**AMERICAN TRANSMISSION SYSTEMS, INCORPORATED  
A SUBSIDIARY OF FIRSTENERGY CORP.**

**AMENDMENT TO EAST SPRINGFIELD-LONDON-  
TANGY 138 kV TRANSMISSION LINE**

**OPSB CASE NO.: 13-2112-EL-BTA**

**October 29, 2013**

FIGURE 04-1A

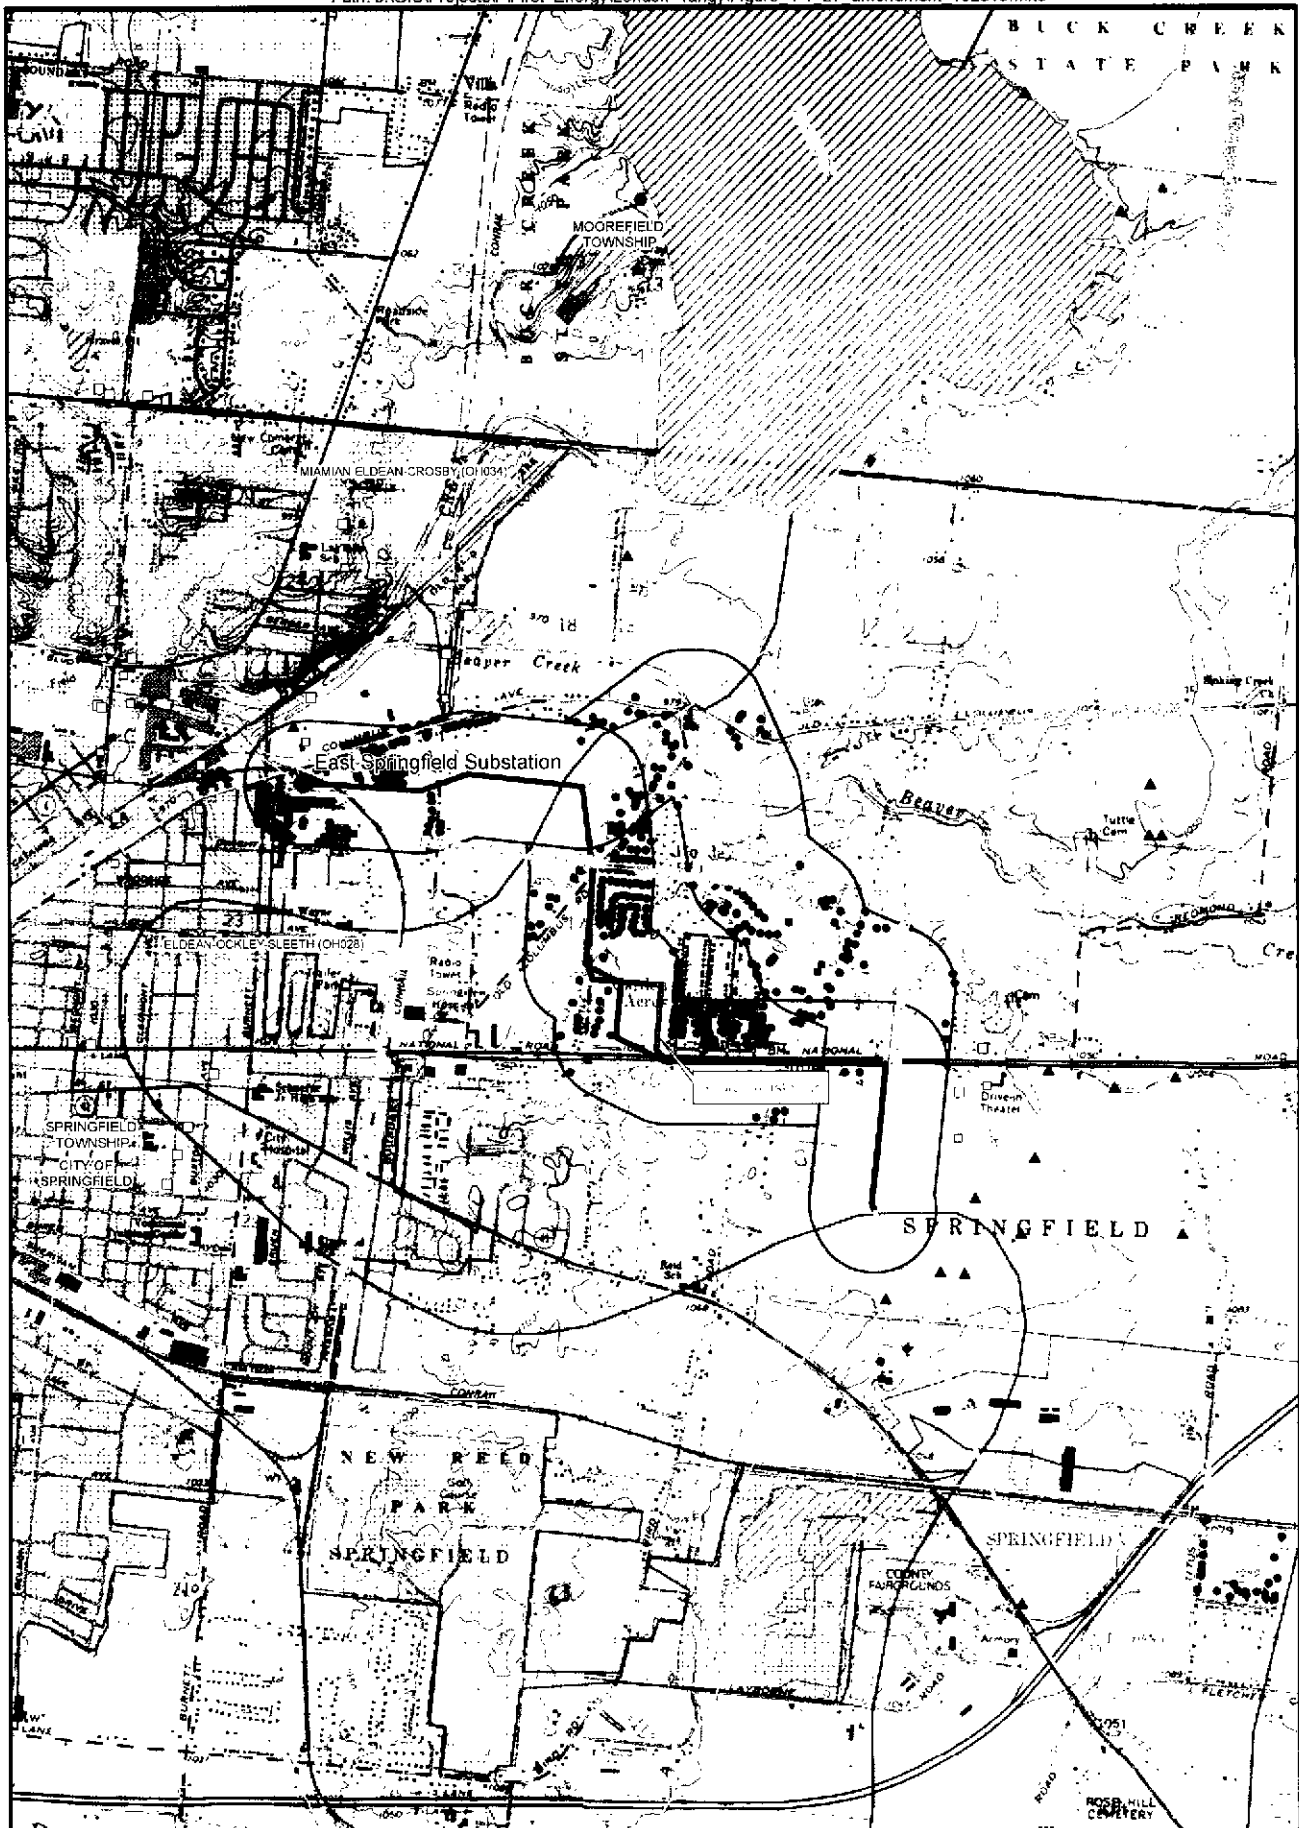
As shown in Figure 04-1A Revision 1, after paralleling the western side of North Tuttle Road, the Approved Route turns to the southeast across North Tuttle Road for 620 feet where it then turns approximately 70 degrees southerly and traverses

approximately 925 feet where it then turns approximately 70 degrees southeasterly for 830 feet across U.S. Highway 40.

The proposed adjustment of the Approved Route in this area begins on the west side of the North Tuttle Road right-of-way. At this point, the adjusted route will turn approximately 30 degrees south-southeasterly and traverse approximately 220 feet across North Tuttle Road before turning approximately 80 degrees to the east. The adjusted route continues east for approximately 1,100 feet where it turns approximately 90 degrees to the south and traverses approximately 1,040 feet to a point just outside the northern edge of the U.S. 40 right-of-way. The adjust route then turns approximately 45 degrees to the southeast for 260 feet, crossing U.S. 40, and rejoining the Approved Route.

The primary property owners along this section of the Approved Route on the north side of U.S. Highway 40 have requested this change to the Approved Route. The Applicant has no objections to the change of the Approved Route requested by the property owners and the change does not increase or decrease ecological impacts. The requested change shifts the route from the western portion to the eastern portion of the High Street Church of the Nazarene parcel. The Approved Route was situated parallel to the rear property lines of five homes along North Tuttle Road. The proposed route adjustment is situated parallel to the rear property lines of fourteen homes along Larchmont Drive. These fourteen homes are approximately 250 feet from the proposed route adjustment, which is about 600 feet closer than they had been from the Approved Route. A total of 49 additional residences are within 1,000 feet of the proposed route adjustment, predominantly along Larchmont Drive, Birch Road, and Redwood Boulevard to the northeast.

FIGURE 04-1F  
REVISION 1  
CONSTRAINTS MAP FOR  
THE LONDON-TANGY SEGMENT

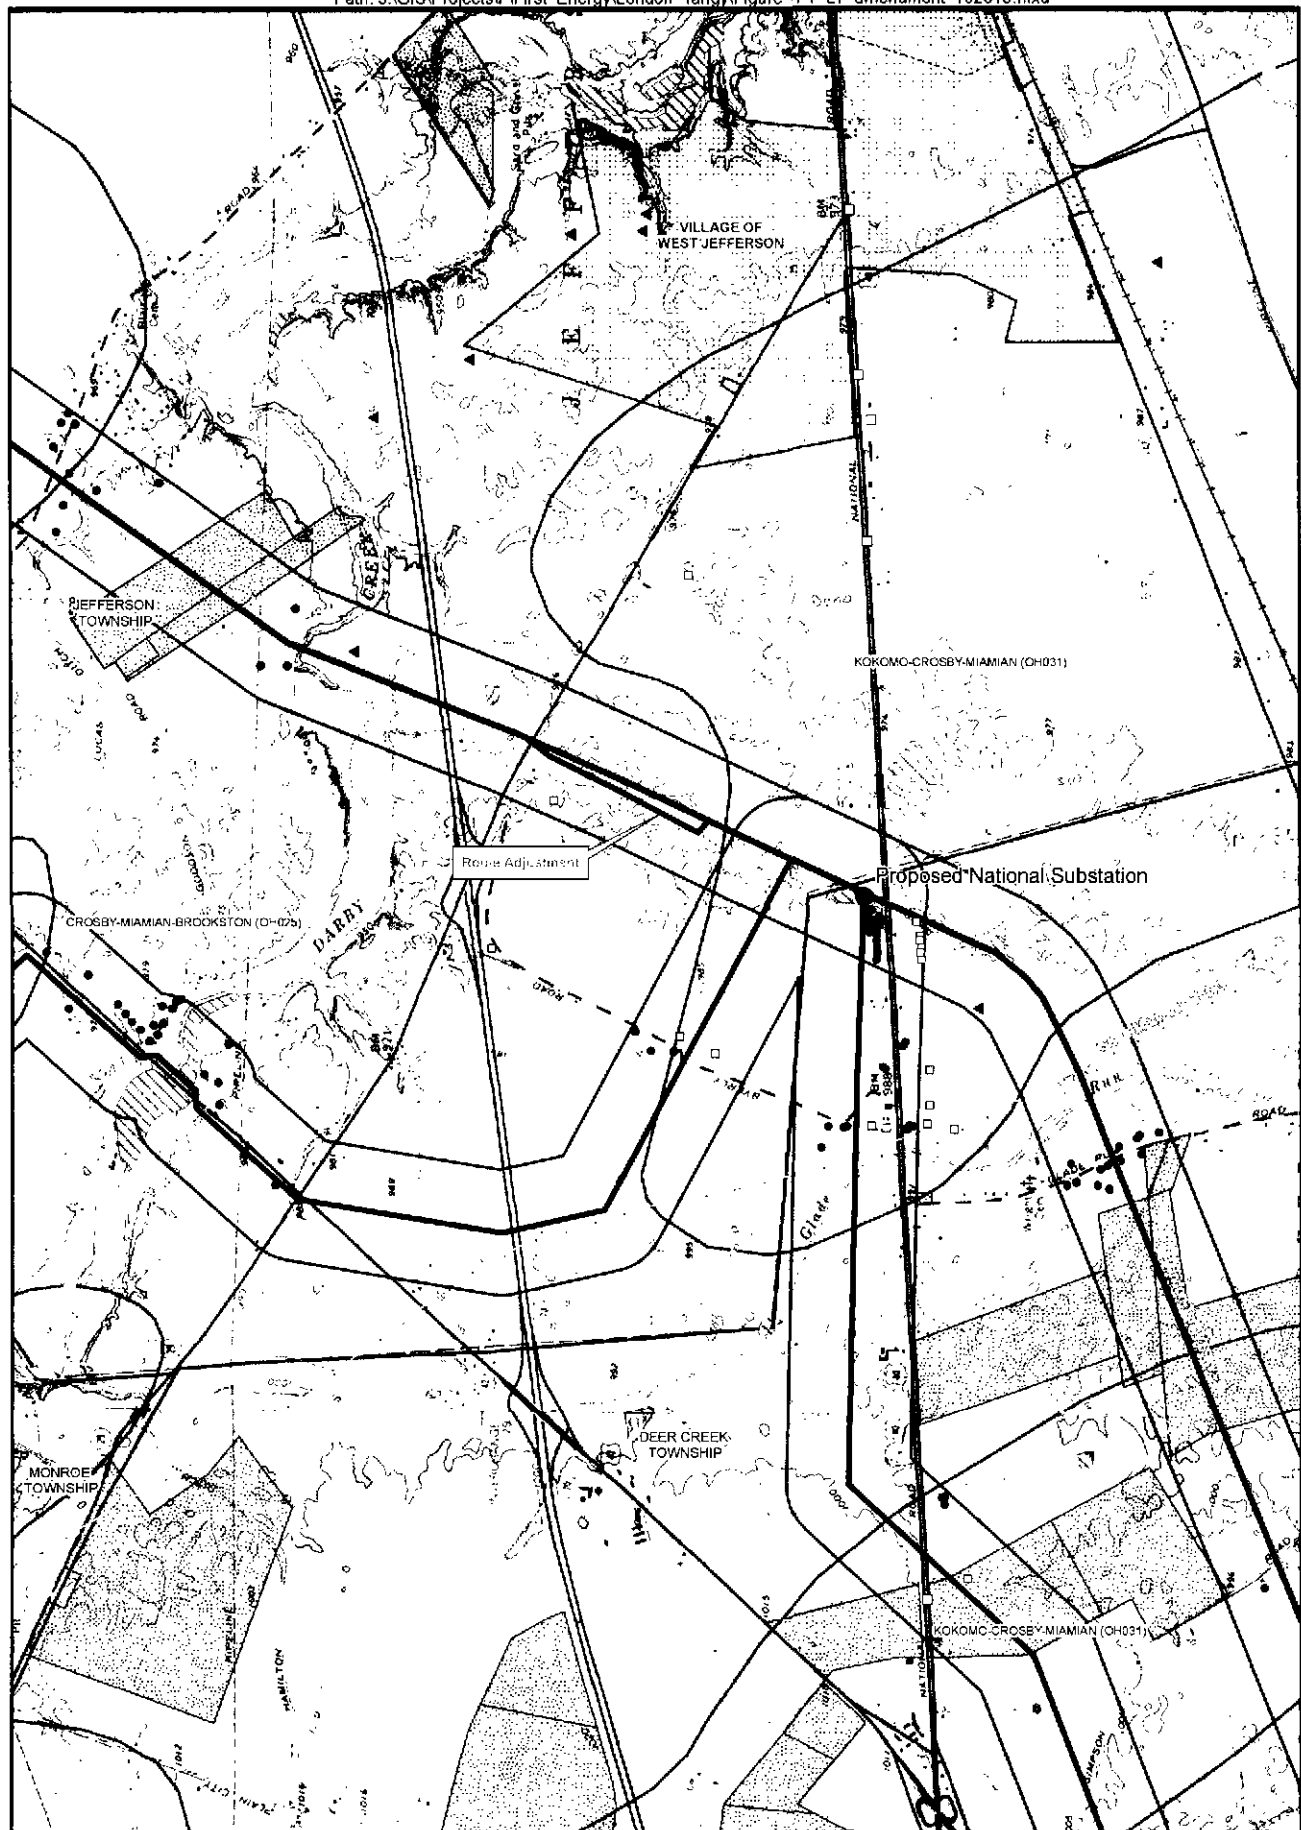
As shown in Figure 04-1F Revision 1, the Approved Route parallels Commerce Parkway spanning stormwater ponds and parking areas of a commercial warehouse building prior to crossing over State Route 29 Northeast. The change to the Approved Route begins on the section of the route that is northeasterly trending approximately 3,000-feet north of U.S. Highway 40. At this point, the adjusted route of the transmission line will turn approximately 75 degrees northwest and traverse approximately 190 feet northwesterly before turning approximately 75 degrees to the north-northeast. The adjusted route continues generally north for approximately 0.5-mile where it turns slightly 15 degrees to the northeast and continues approximately 300 feet before rejoining the Approved Route near State Route 29 Northeast.

The proposed adjustment is requested by the Applicant and is beneficial as it avoids pole placement and spanning of three stormwater ponds and commercial parking areas. The property owners have agreed to this proposed alignment for

FIGURE 04-11  
REVISION 1  
CONSTRAINTS MAP FOR  
THE LONDON-TANGY SEGMENT

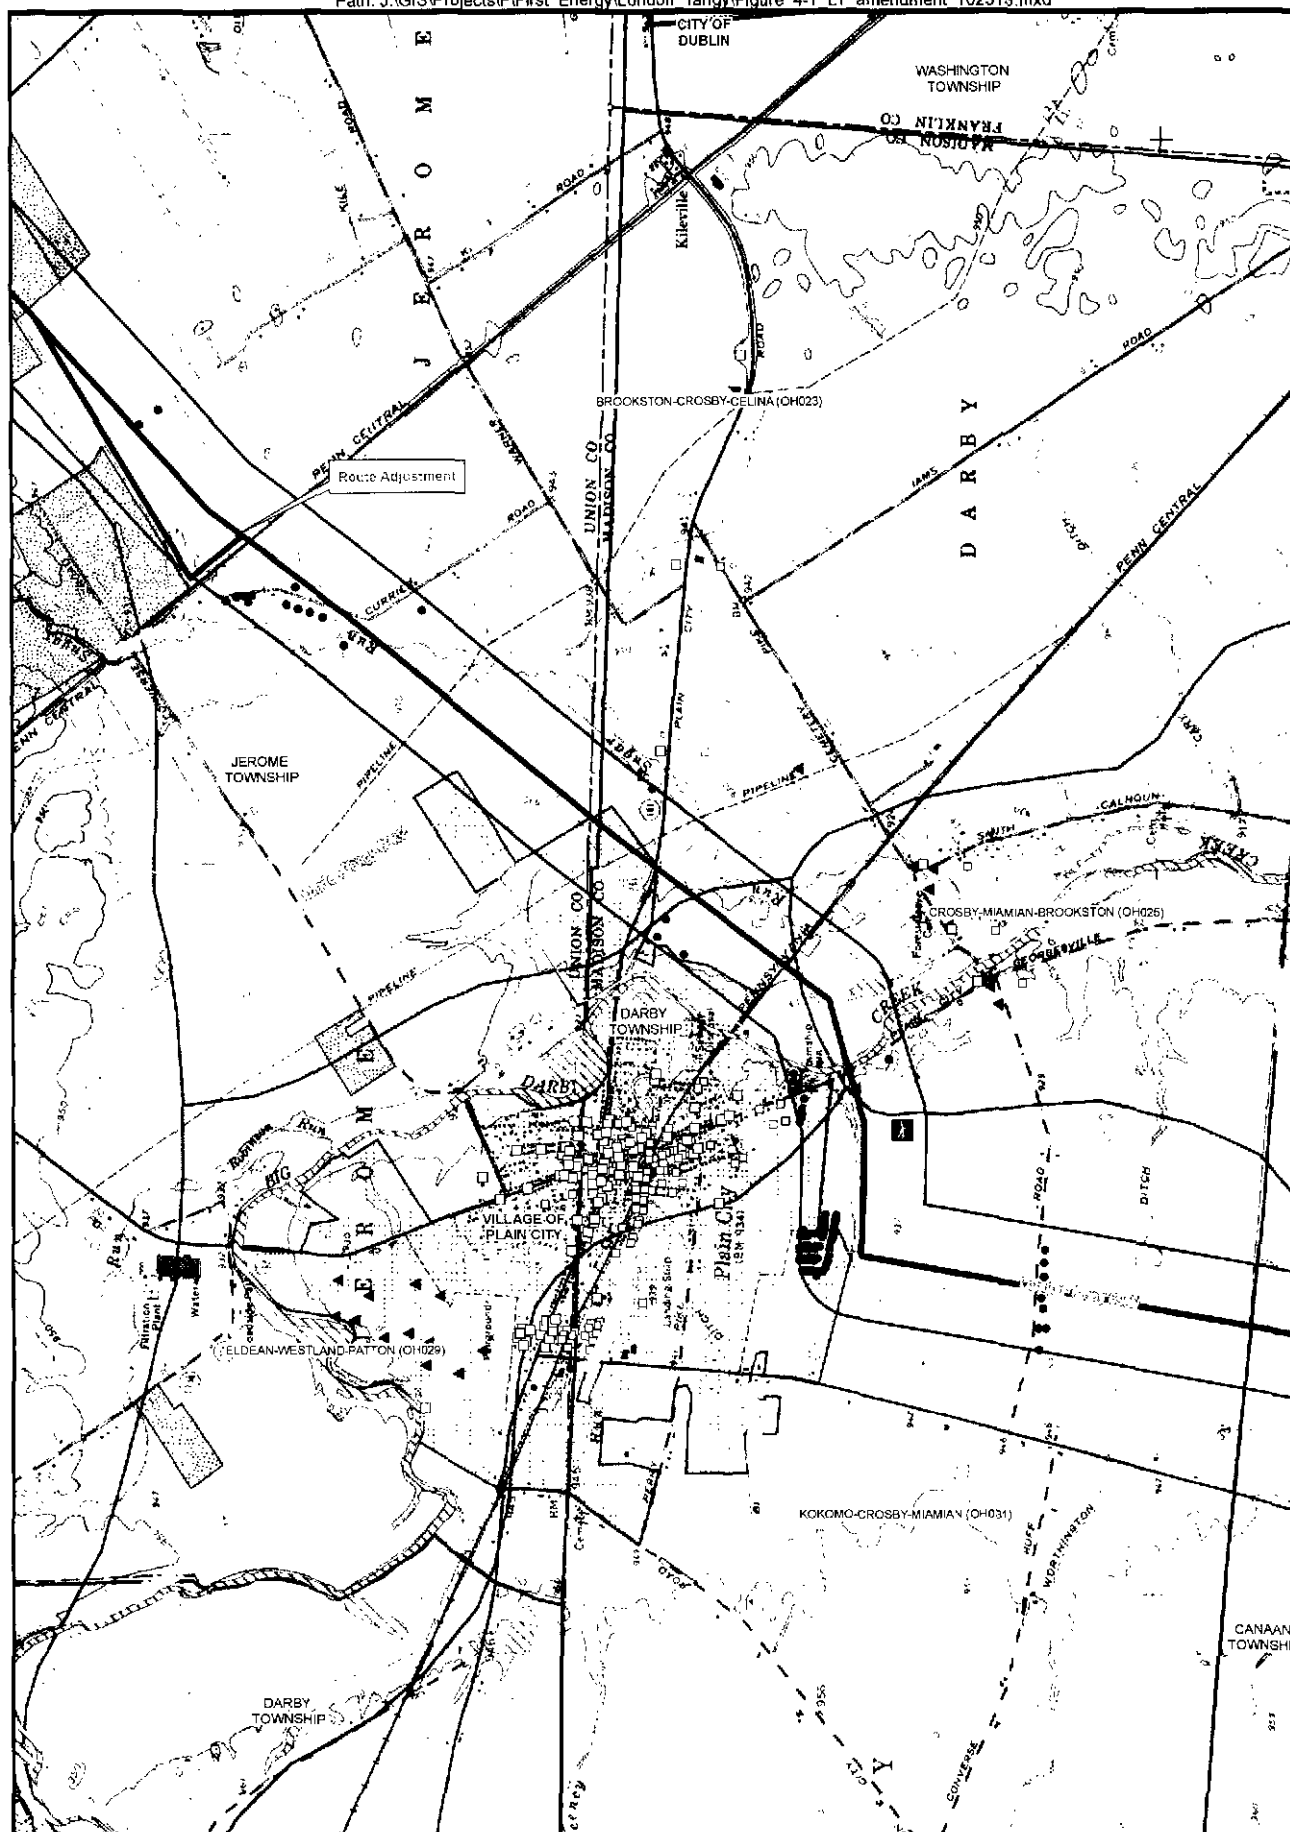
As shown in Figure 04-1I Revision 1, after the north-northeast trending crossing of the Currier Road and railroad tracks, the Approved Route continues north-northeast for approximately 800 feet, where it then turns slightly 10 degrees and continues generally northeast. The proposed adjustment of the Approved Route in this area begins on the north side of the railroad right-of-way. At this point, the adjusted route of the transmission line will turn approximately 80 degrees westerly and traverse approximately 1,050 feet before turning approximately 85 degrees to the northeast. The adjusted route continues generally northeast for approximately 0.9-mile where it rejoins the Approved Route.

The Approved Route is located in close proximity to the residence of a property owner, Tina J. Long (parcel numbers 1500250310000 and 1500260010000). The Applicant's discussions with Ms. Long identified both the Applicant's and Ms. Long's willingness to locate the transmission further from the residence while

FIGURE 04-1K  
REVISION 1  
CONSTRAINTS MAP FOR  
THE LONDON-TANGY SEGMENT

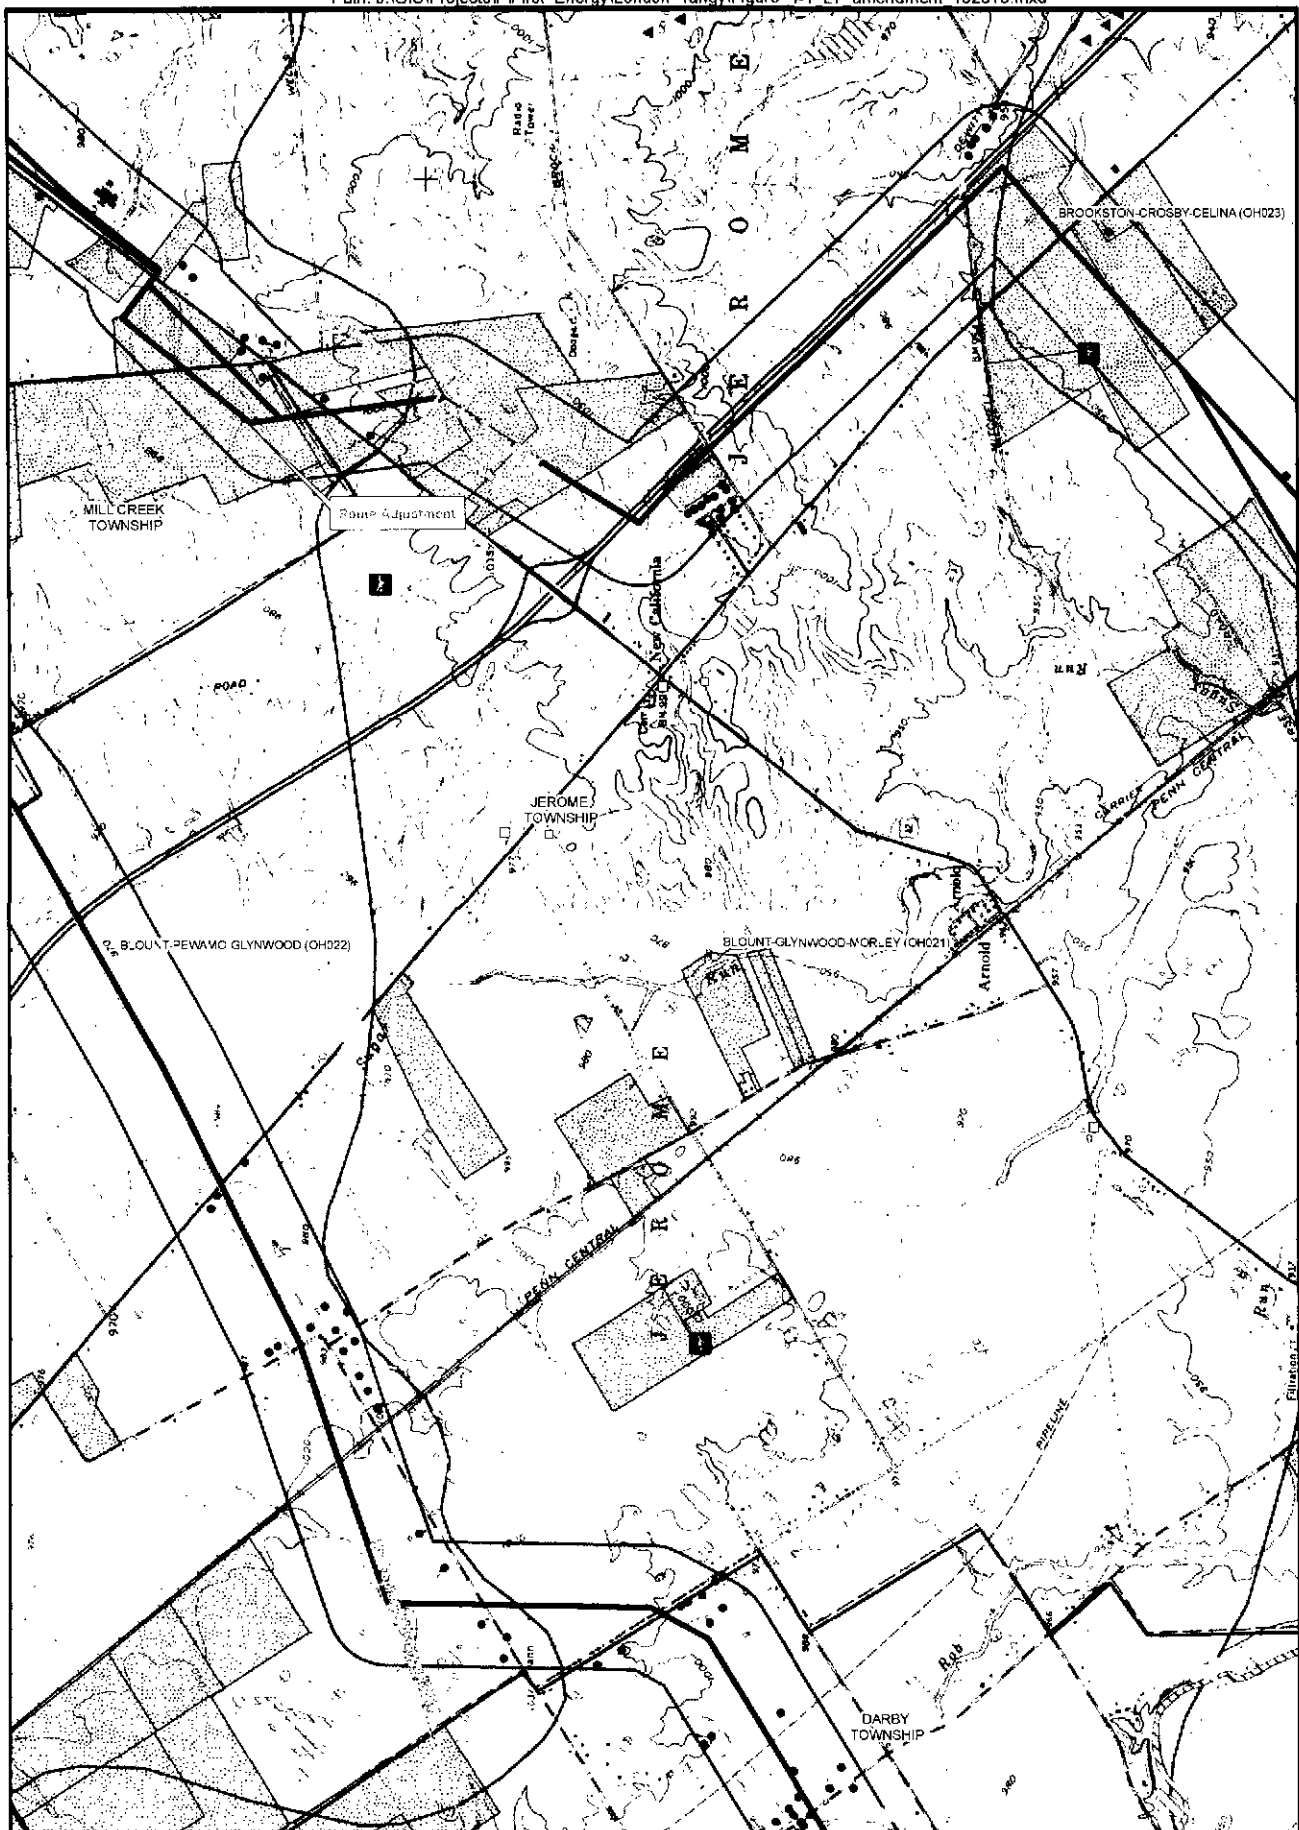
As shown in Figure 04-1K Revision 1, after the northerly trending crossing of U.S. Highway 42 North, the Approved Route continues northerly for approximately 780 feet, then turns approximately 55 degrees northeasterly and traverses approximately 0.6 mile where it then turns approximately 80 degrees to the southeast and crosses back over U.S. Highway 42 North. The proposed adjustment of the Approved Route in this area begins approximately 780 feet to the north of U.S. Highway 42 North. At this point, the adjusted route of the transmission line will continue approximately 500 feet to the north where it then turns approximately 45 degrees to the northeast and traverse approximately 0.5-mile before turning approximately 90 degrees to the southeast. The adjusted route continues generally southeast for approximately 700-feet and rejoins the Approved Route.

The property owner along this section of the Approved Route has requested the change of the Approved Route. The Applicant has no objection to the change of the Approved Route requested by the property owner and believe the change does not significantly increase or decrease ecological impacts. The requested change shifts the Approved Route an additional approximately 450-feet to the north away from nearby residences and further into an agricultural field.
